AP1000 DOCUMENT NO.	REVISION	PAGE	ASSIGNED TO	OPEN ITEMS (Y/N)
APP-GW-GLR-134	1	1 of 470	W-Sterdis

TITLE: **AP1000 DCD Impacts to Support COLA Standardization**

AP1000 Standard Combined License Technical Report

Figure 7.2-1 (Sheet 20 of 20)

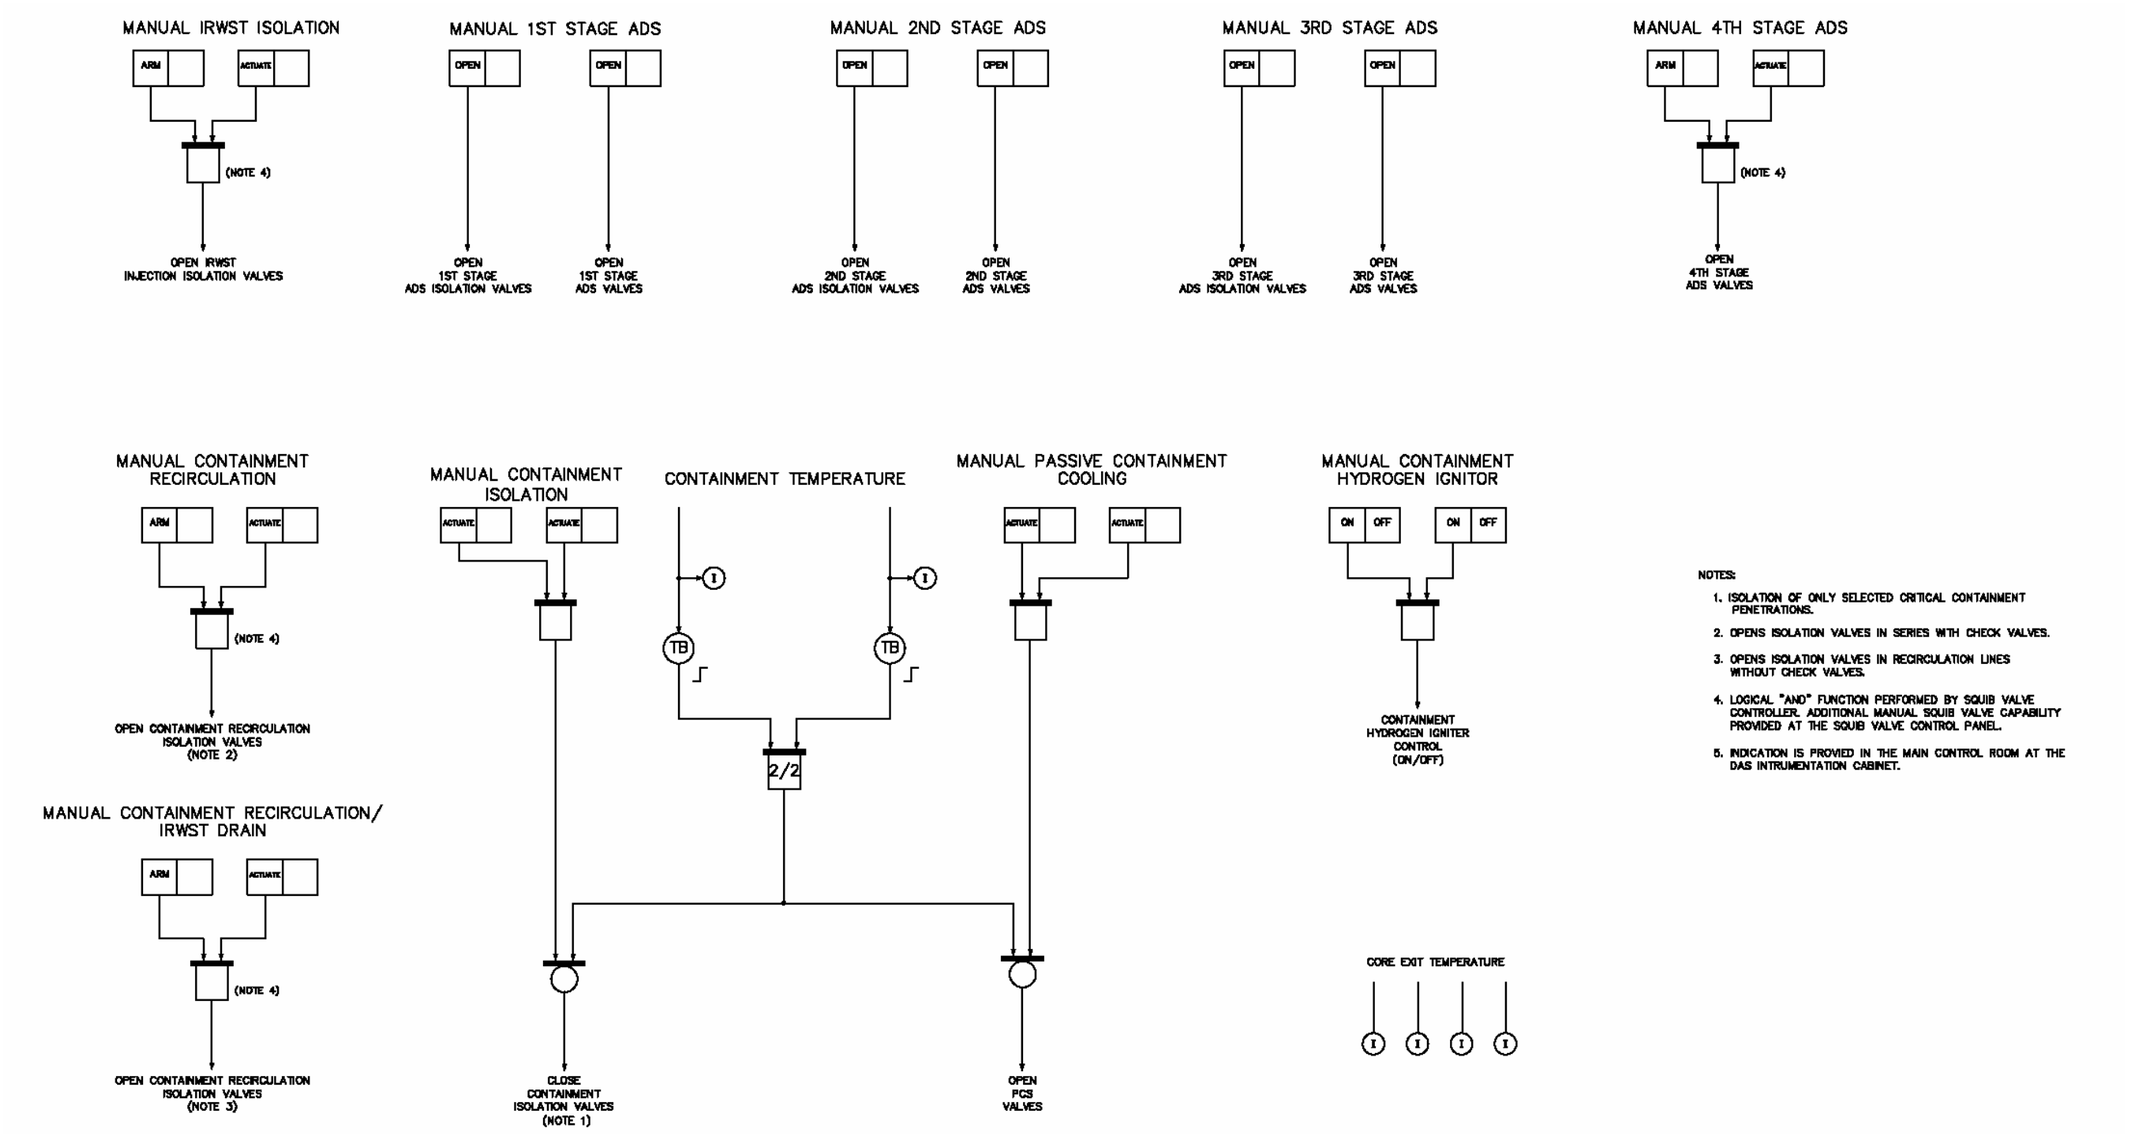
NRC 138 has changes to the notes of Figure 7.2-1 (sheet 20 of 20) to be consistent with RAI-TR97-ICE-03.

Figure 9.3.6-1 (Sheet 1 of 2)

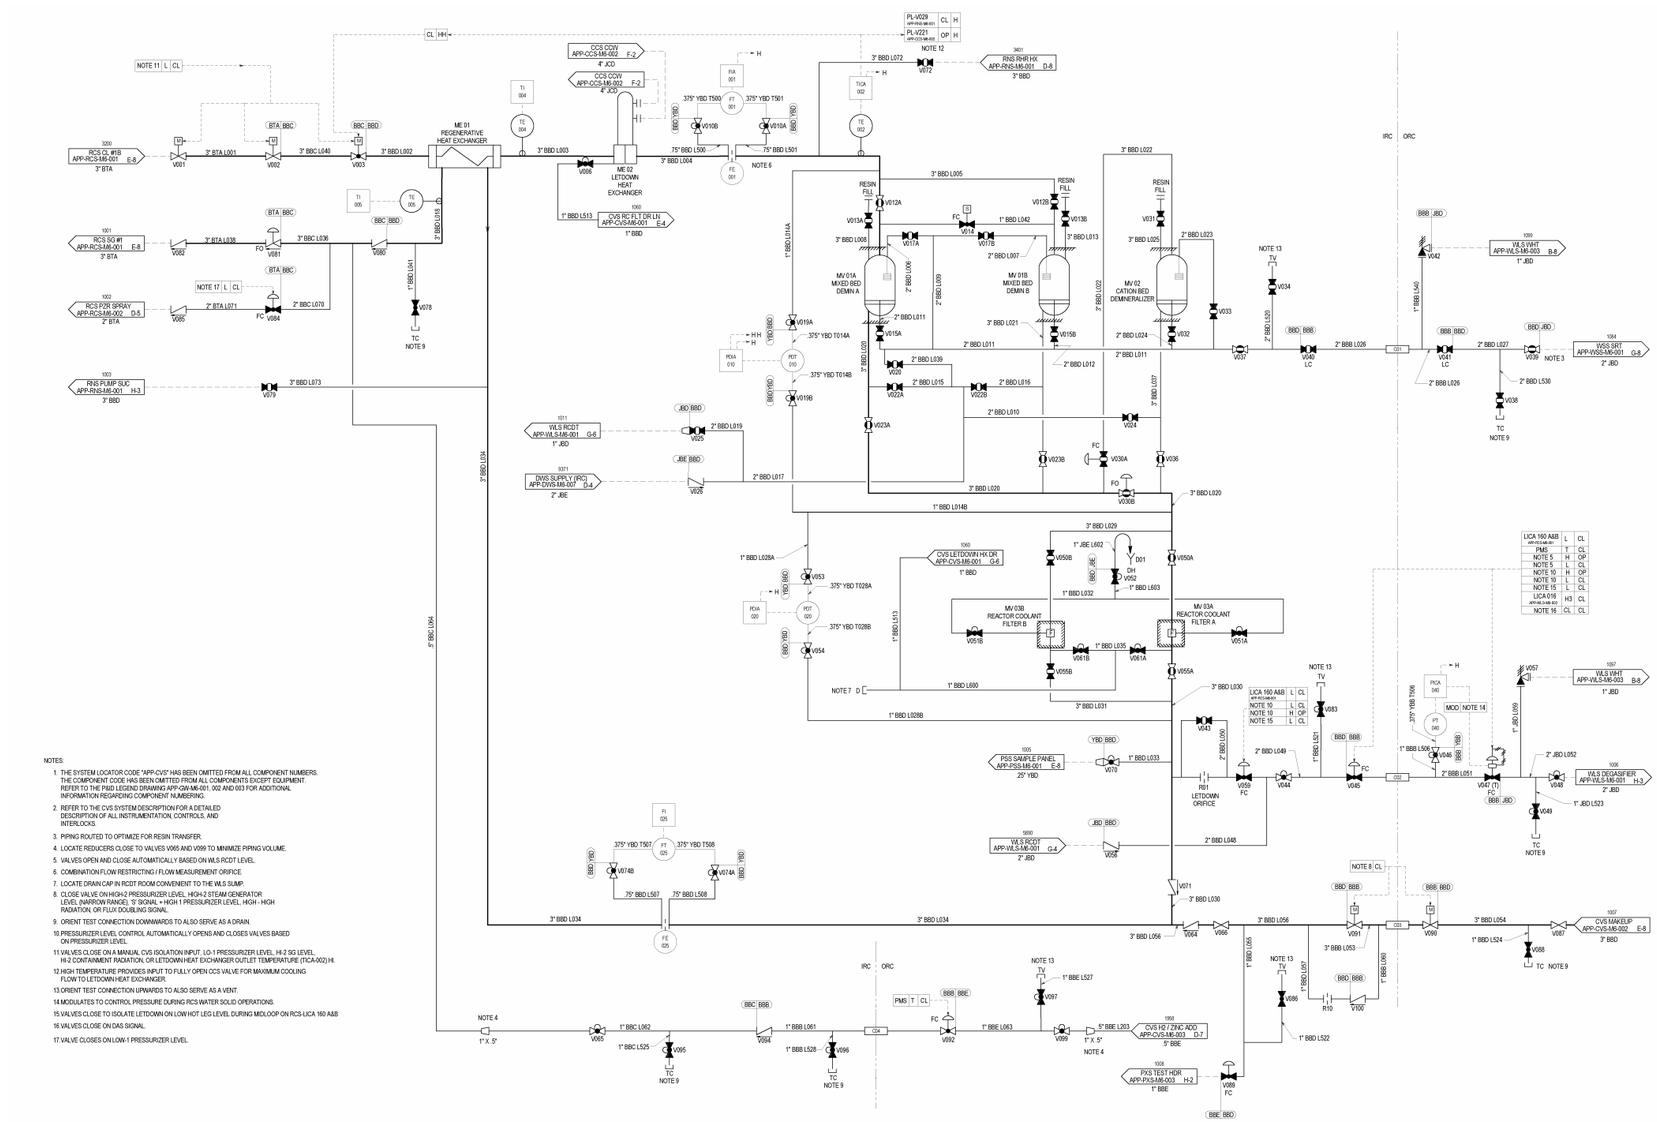
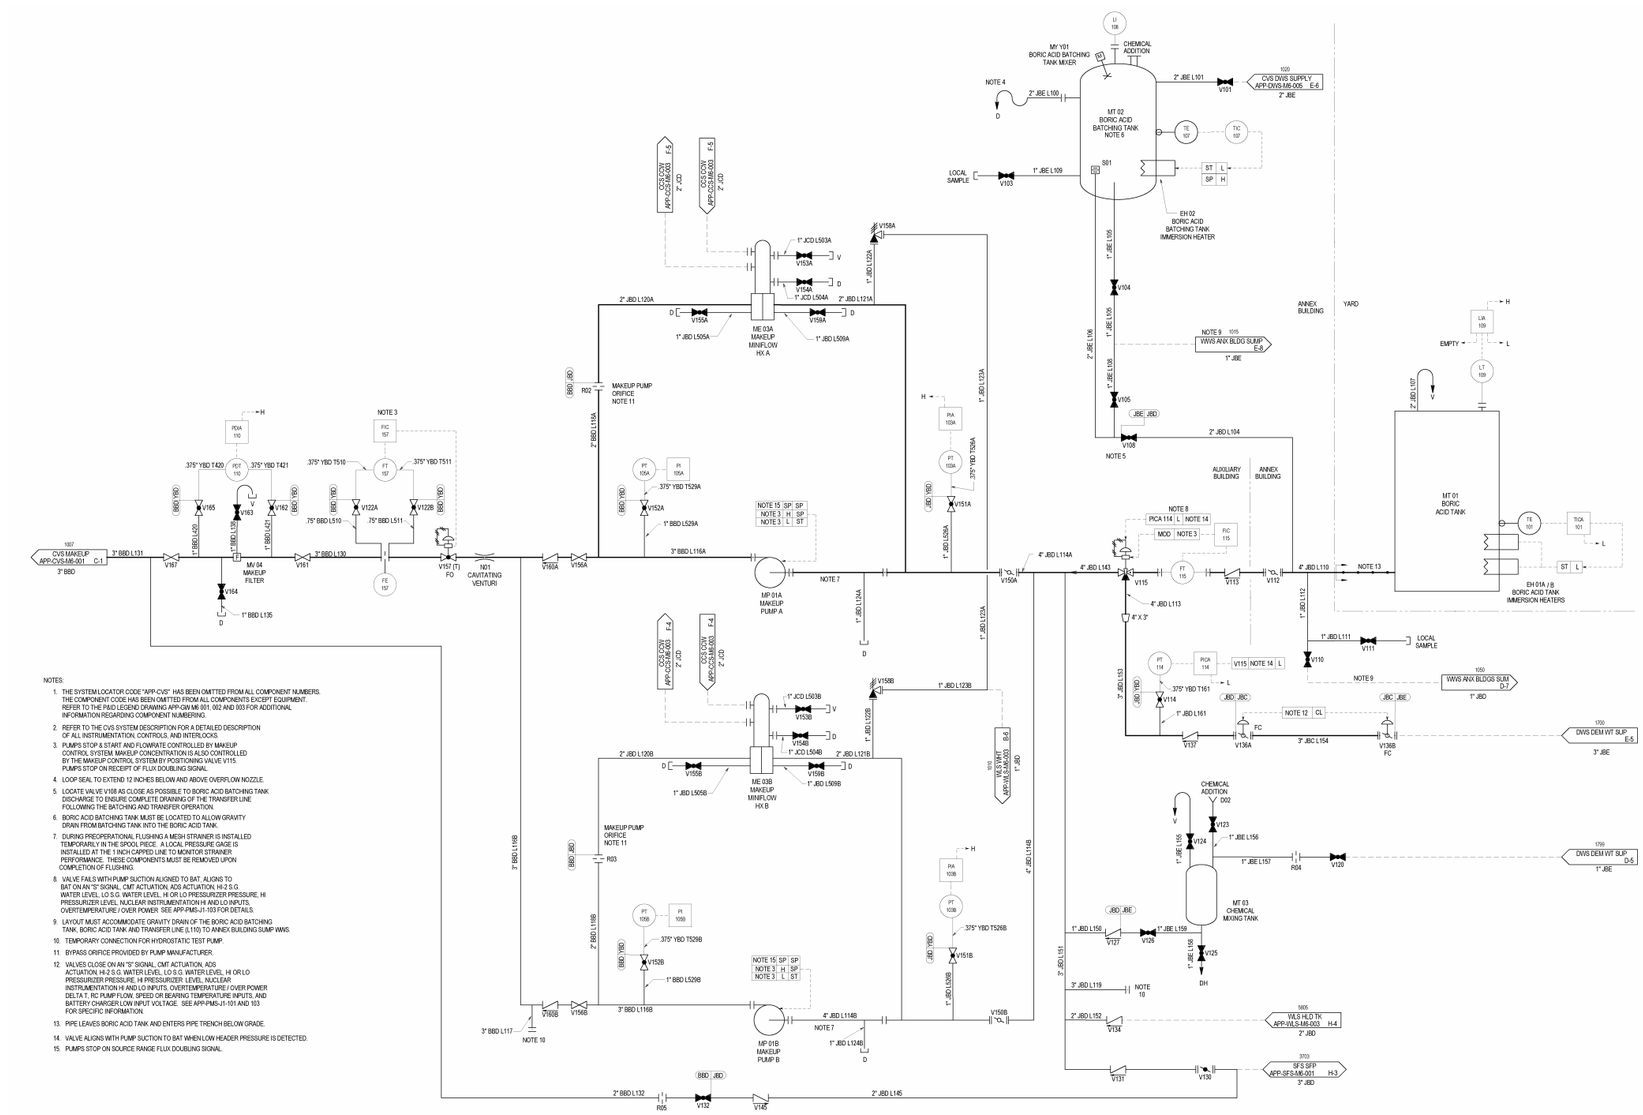
NRC157 contains changes to Section 9.3.6.3.7, 9.3.6.4.5.1, 9.3.6.6.1.2, 9.3.6.7 anf Figure 9.3.6-1(Sheets 1 & 2) of the DCD Revision 16 to be consistent with APP-GW-GLR-080,Rev 0.

Figure 9.5.4-1 (Sheet 2 of 3)

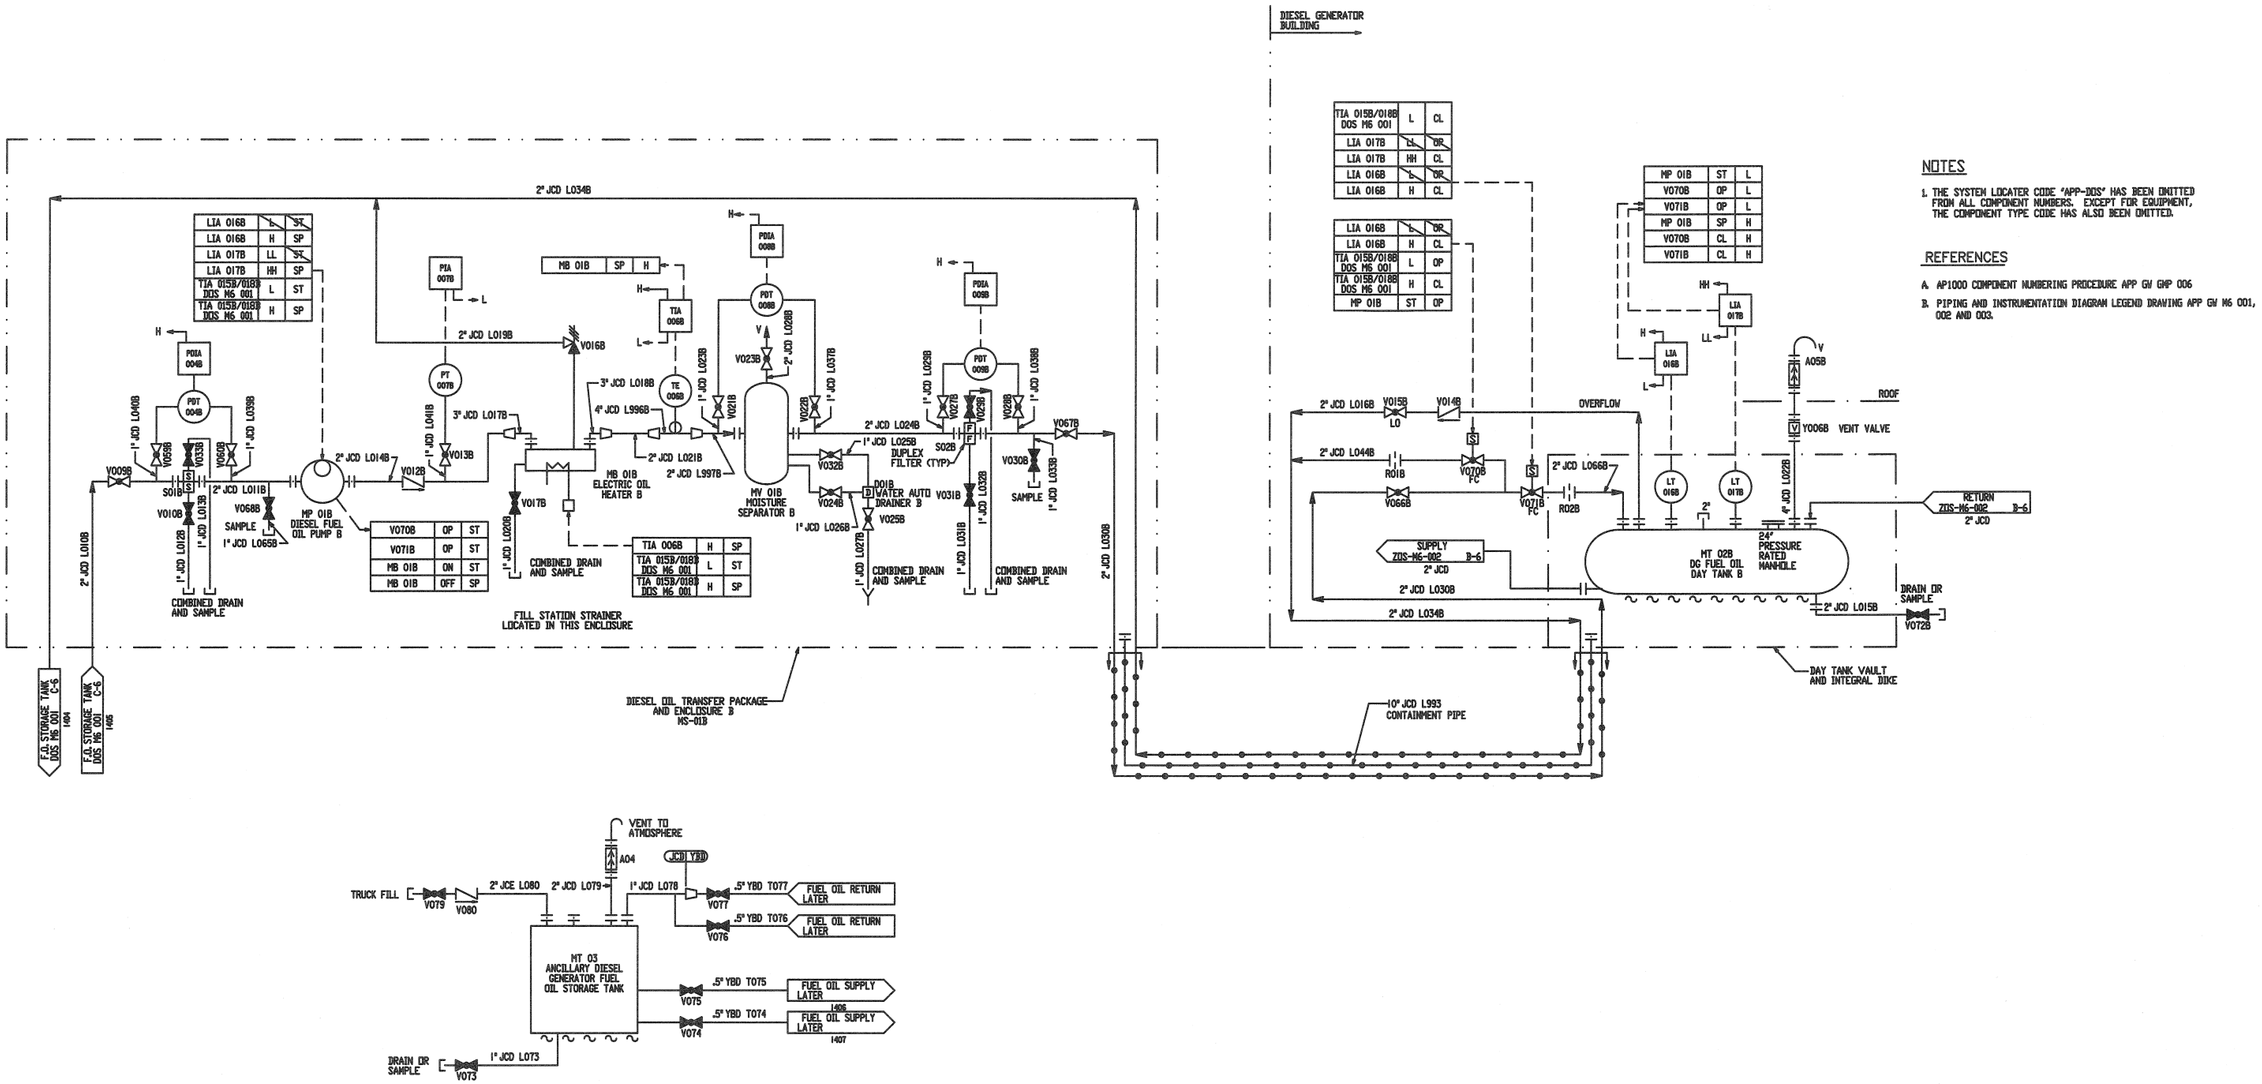
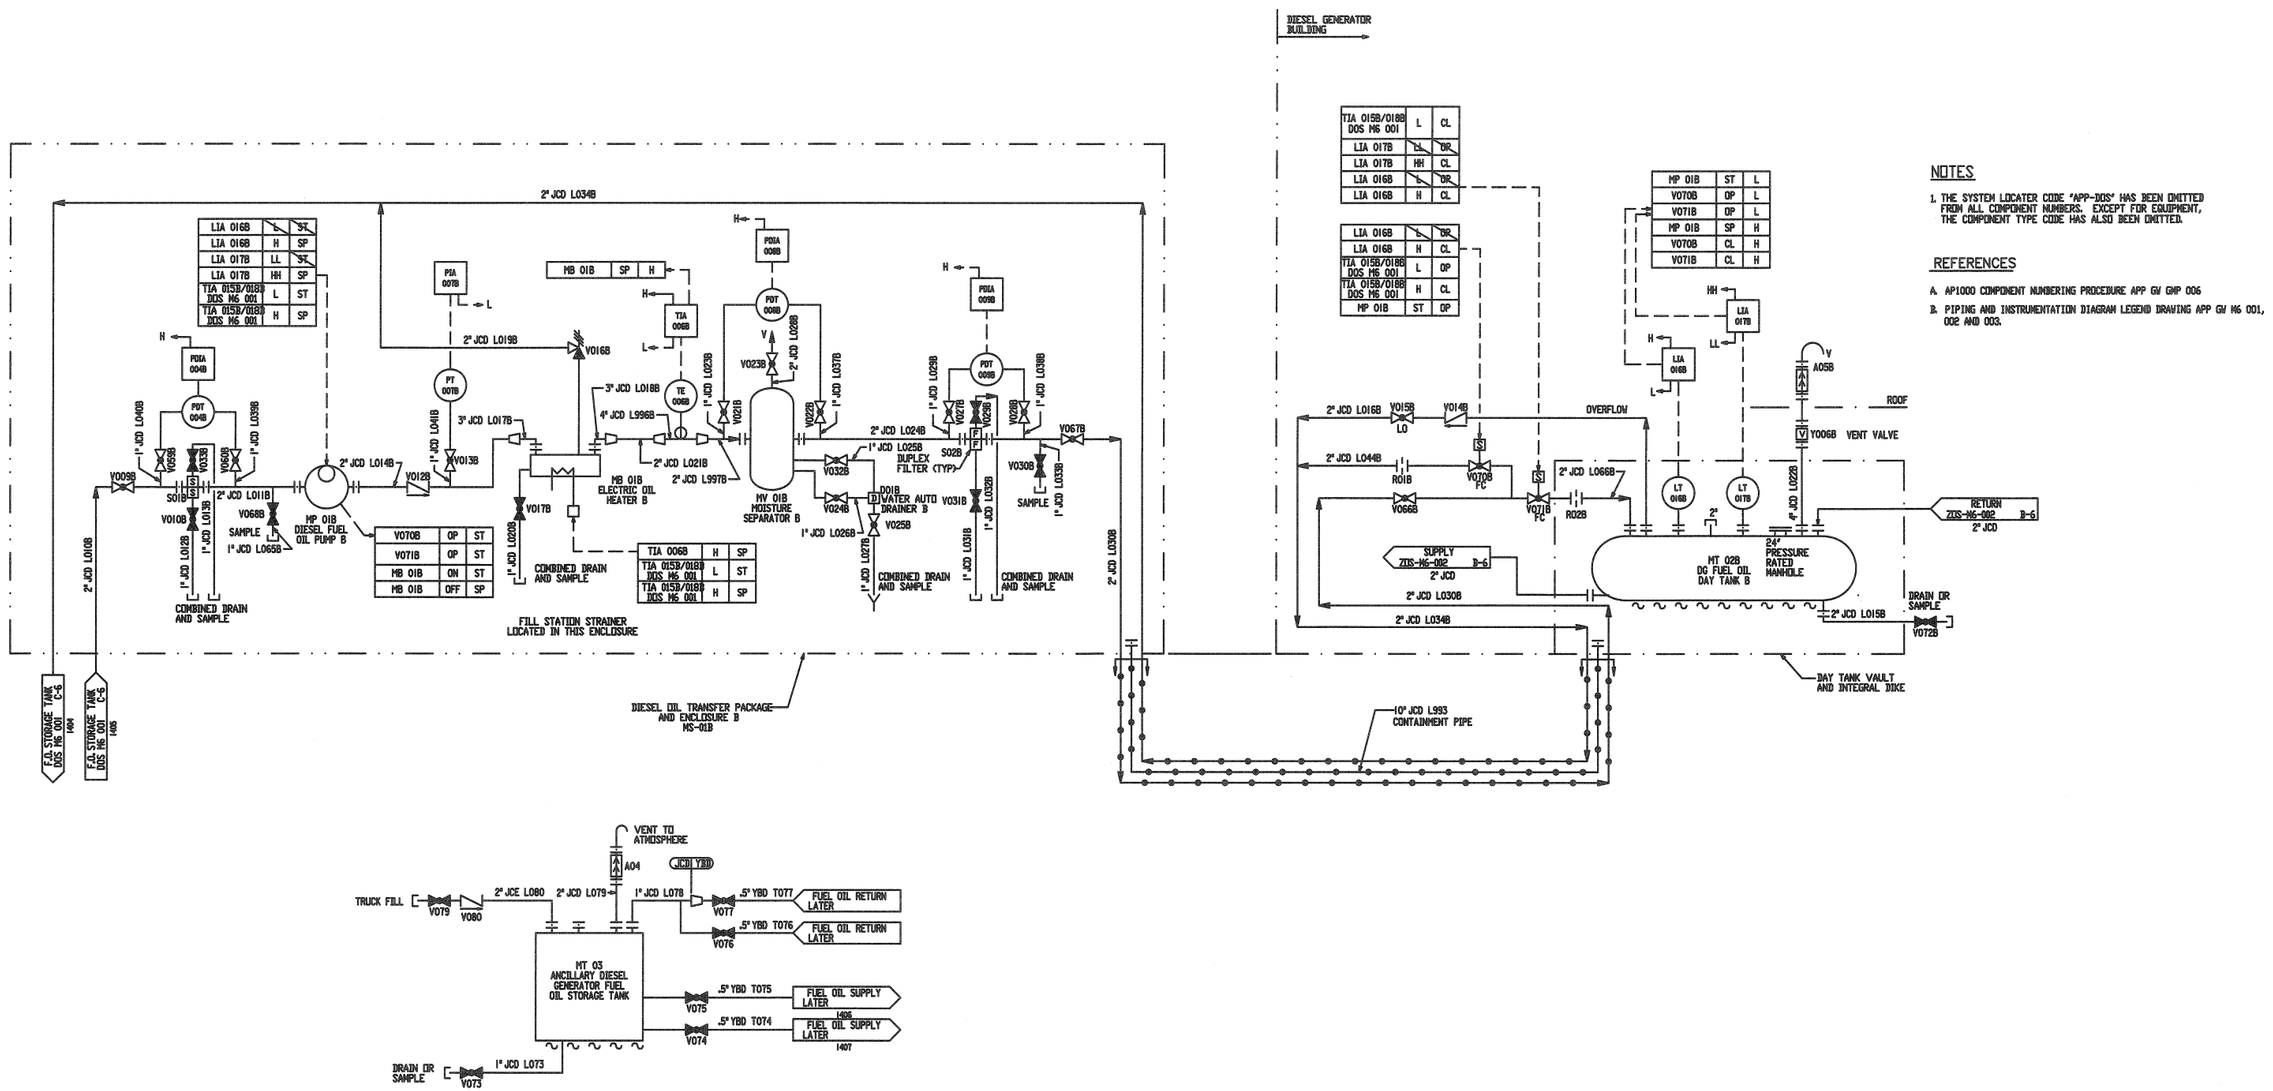
NRC 072 contains changes to Figures 9.5.4-1 (Sheets1,2,and3)of the DCD Revision 16 to delete Auxiliary Boiler out of the title.
